NSW Draft Work Health and Safety (Mines) Regulation 2014

Coal Assets Australia

On behalf of: Coal Assets Australia, Glencore (GCAA)

Version FINAL

Figure 2 - NSW WHS Legislative Framework – Mines

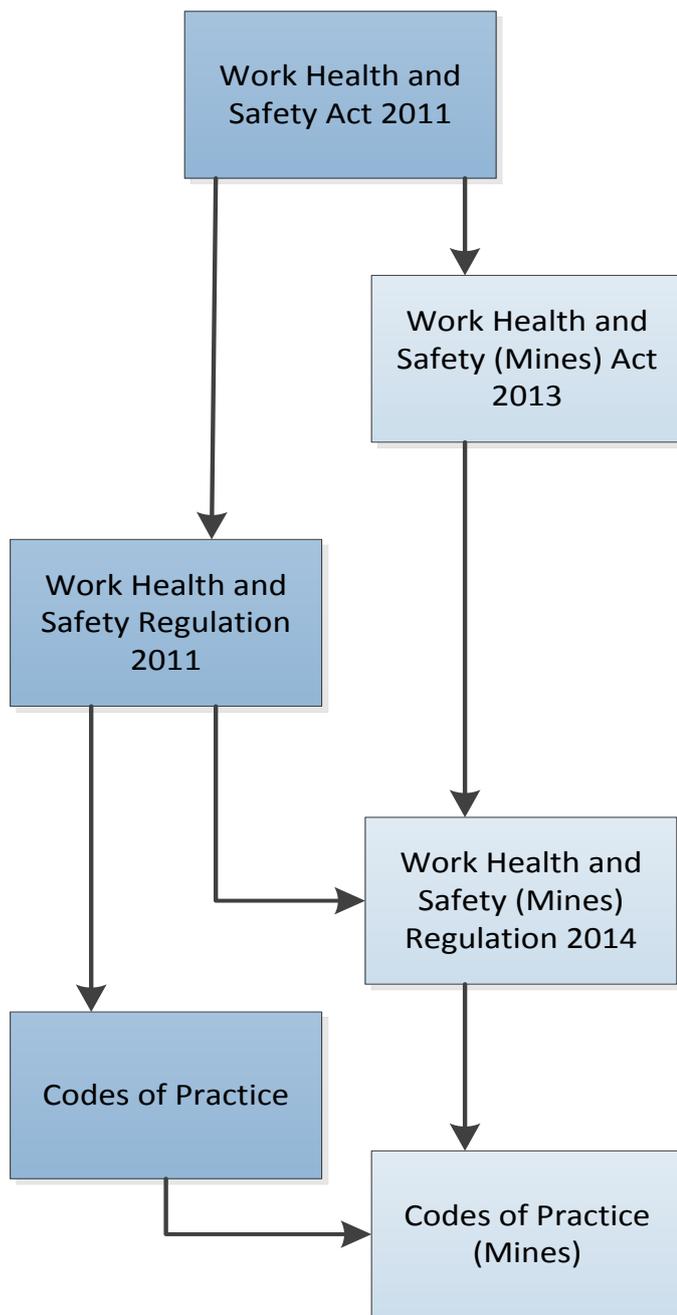
We have found that the diagram detailing the framework of WHS legislation in the Discussion Paper for the draft regulation (page 13) is not consistent with clause 4 in both the WHS (Mines) Act 2013 and the draft regulation. We have interpreted from these clauses that a more accurate representation of the framework would be that set out below in Figure 2.

We have also interpreted from the WHS regulation that in the case of any inconsistency between this regulation and the draft mines regulation that the WHS Regulation prevails (*Refer Work Health and Safety Regulation 2011 – Clause 14 Inconsistencies between provisions - If a provision of any document applied, adopted or incorporated by, or referred to in, this Regulation is inconsistent with any provision in this Regulation, the provision of this Regulation prevails*).

Action: Confirmation is required regarding the above representation of the framework and the interpretation regarding inconsistencies is accurate.
